PRODUCT / PROCESS CHANGE NOTIFICATION

PCN-000864

Alternate flex cable supplier DSN (LongZee Electronic Ltd.) has been qualified for multiple Semtech ROSA products, listed on page 2 of this PCN. This supplier is already qualified for multiple other ROSA products.

F10047 – Compass Flex part number

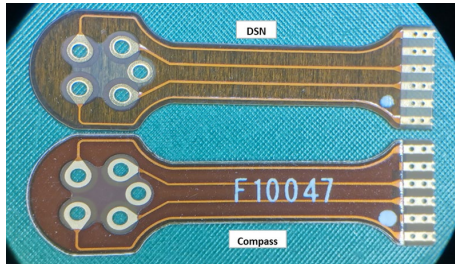
The purpose of change is to address supply chain constrains with the currently single sourced supply. Following flex cable part numbers will now have dual source: F10026, F10036, F10037, F10047, F10059, F10068, F10069.

F10047 – Flex Part Number
B – Revision of DSN Flex (only applied for F10047 & F10048)
DSN – Flex Supplier
4220 – Manufacturing Date Code

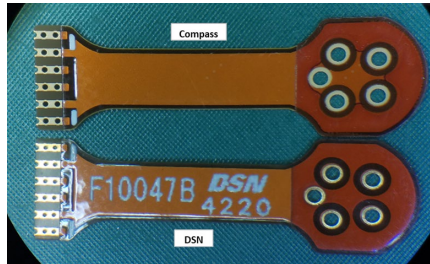
- The B marking on DSN flex will be removed beginning January 15, 2023, or until current stocks are depleted.
- DSN flex will retain the DSN and Manufacturing Date Code markings.
- There will be no changes to the Compass flex marking.
